Request for Quotation

RFQ NUMBER
 DCH12107

LINE	QUANTITY	UOP	CAT. NO.	ITEM NUMBER	UNIT PRICE	AMOUNT
ADDENDUM NO. 1						
1. QUESTIONS AND ANSWERS ARE ATTACHED. 2. PRE-BID SIGN IN SHEETS ARE ATTACHED. 3. ADDENDUM ACKNOWLEDGEMENT IS ATTACHED. THIS DOCUMENT SHOULD BE SIGNED AND RETURNED WITH YOUR BID. FAILURE TO SIGN AND RETURN MAY RESULT IN DISQUALIFICATION OF YOUR BID.						
EXHIBIT 10						
REQUISITION NO. DCH12107						
ADDENDUM ACKNOWLEDGEMENT						
I HEREBY ACKNOWLEDGE RECEIPT OF THE FOLLOWING CHECKED ADDENDUM(S) AND HAVE MADE THE NECESSARY REVISIONS TO MY PROPOSAL, PLANS AND/OR SPECIFICATION, ETC.						
ADDENDUM NO.'S:						
NO. 1.....						
NO. 2.....						
NO. 3.....						
NO. 4.....						
NO. 5.....						
I UNDERSTAND THAT FAILURE TO CONFIRM THE RECEIPT OF THE ADDENDUM(S) MAY BE CAUSE FOR REJECTION OF BIDS.

WV Museum Collections Storage

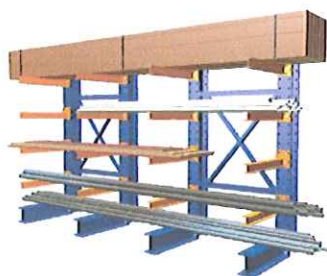
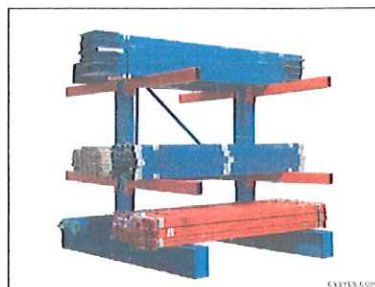
Question 11 - On page 24 under Shelving Units Installation (section E.6.a), you discuss the heavy duty Cantilever Shelving. A) How deep are the single/double cantilever sections you are requesting? You do not mention shelves for these units. B) Do they have shelves?

As stated on page 26, E6a 1), Cantilever shelving for the first unit is one (1) single-sided four (4) feet (48 inches) deep unit and two (2) double-sided, four (4) feet (48 inches) deep unit. The double-sided unit will be placed on a carriage unit capable of holding it. The Cantilever shelving does not have shelves, rather they are designed with posts that have adjustable heavy duty arms extending the distance of the base/not protruding out from the carriage. The requirement is for five (5) posts per unit with 5 adjustable arms per post. Posts and arms

are required to hold (at a minimum) the same weight bearing loads as the carriages and shelving units. (1,000 lbs. per linear foot).
